CZ-23-1246656

STAFF ANALYSIS

Case No.:	CZ-23-1246656	Agenda #: 2023-1150
Location/Address:	1716 Pleasant Hill Trail, 7956, 7890, 8024, 7799, 7900 & 7860 Pleasant Hill Road Lithonia, GA 30058	Commission District: 05 Super District: 07
Parcel ID(s):	16-197-03-006, 16-197-03-012, 16-219-01-005, 16-219-01-006, 16-220-01-004, 16-220-01-007 & 16-220-01-009	
Request:	Major modification of zoning conditions pursuant to CZ-18-22130 to construct townhouses within the RNC (Residential Neighborhood Conservation) Zoning District.	
Property Owner(s):	Hybass Properties, LLC	
Applicant/Agent:	Hybass Properties, LLC c/o Battle Law, P.C.	
Acreage:	95.52 acres	
Existing Land Use:	Vacant	
Surrounding Properties:	North: R-100, MU-1, M-2 (Across Pleasant Hill Trail) East: R-85 South: R-85 (Across Pleasant Hill Road) West: R-75	
Comprehensive Plan:	Suburban (SUB) Consistent <input checked="" type="checkbox"/>	Inconsistent <input type="checkbox"/>

Application of Hybrass Properties for a major modification of zoning conditions pursuant to CZ-18-22130 to construct fee-simple townhouses within the RNC (Residential Neighborhood Conservation) zoning district, at Pleasant Hill Trail and Pleasant Hill Road.

CONCEPT PLAN FOR
HYBRASS PROPERTIES, LLC
 LOCATED IN:
 LAND LOTS 197, 219, 220, 16TH DISTRICT
 DEKALB COUNTY, GEORGIA

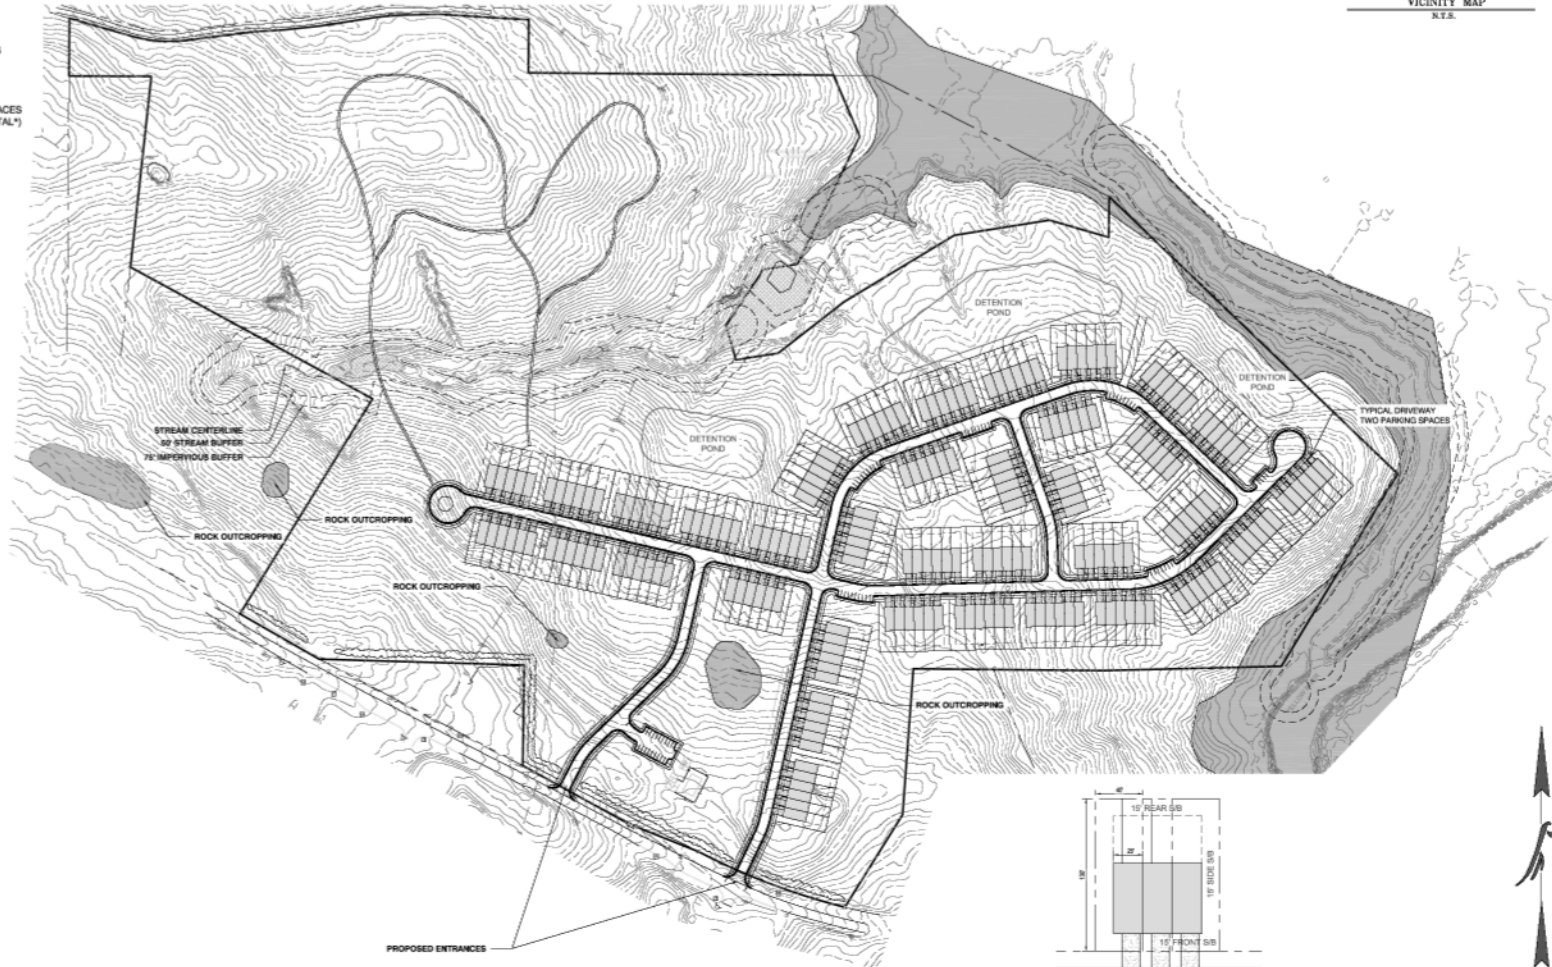
There are potential site plan deficiencies, however, that may affect the configuration and/or potential lot yield with the development:

- The applicant proposes a total of two (2) vehicle access points, down from four (4) that was originally proposed with the original submittal. Per Section 14-200 of the *Land Development Code*, a minimum of three (3) access points is required for residential developments with 151-300 total units. This requirement cannot be waived by a condition of rezoning and can only be addressed by a variance from the Planning Commission.

- The new site plan does not appear to prove compliance with the minimum greenspace requirement as defined per Section 2.10.5. of the *Zoning Ordinance*. A minimum of 30 percent of the total site area shall be dedicated to greenspace, which may not consist of the following features (per Section 2.10.5.(B)):

The site plan shows a development site that appears to have extreme slopes throughout, as well as having state waters/stream buffers. Meeting this greenspace requirement could pose a challenge for development and could affect lot yield.
